Access Compliance Report

Public Rights-of-Way

(Curb Ramps)

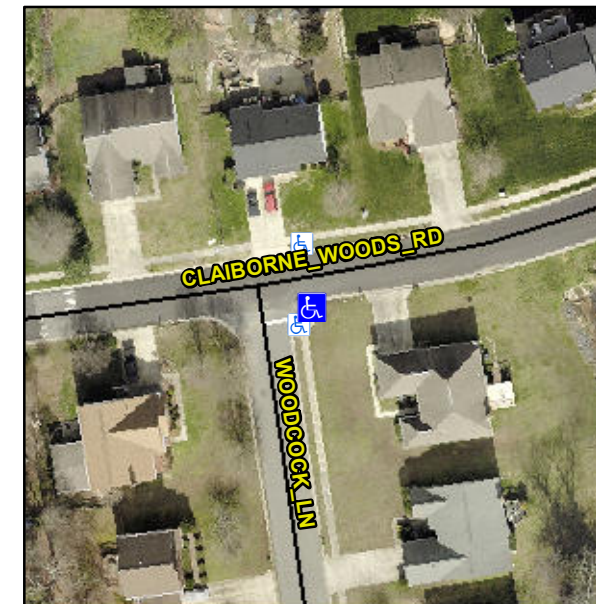
Intersection ID: 3767	Main Street: CLAIBORNE_WOODS_RD	Cross Street: WOODCOCK_LN	Location: SE
ADA ID: EB52CA00B9B2	Ramp Type: Perp	Initial Pass/Fail: Fail	Overall Compliance: No
Severity Score: 42.5			
Codes/Mitigation Info/Possible Solution		Field Measurements/Component Compliance

R304.5.1, R304.5.3

Remove & Replace Entire Ramp.
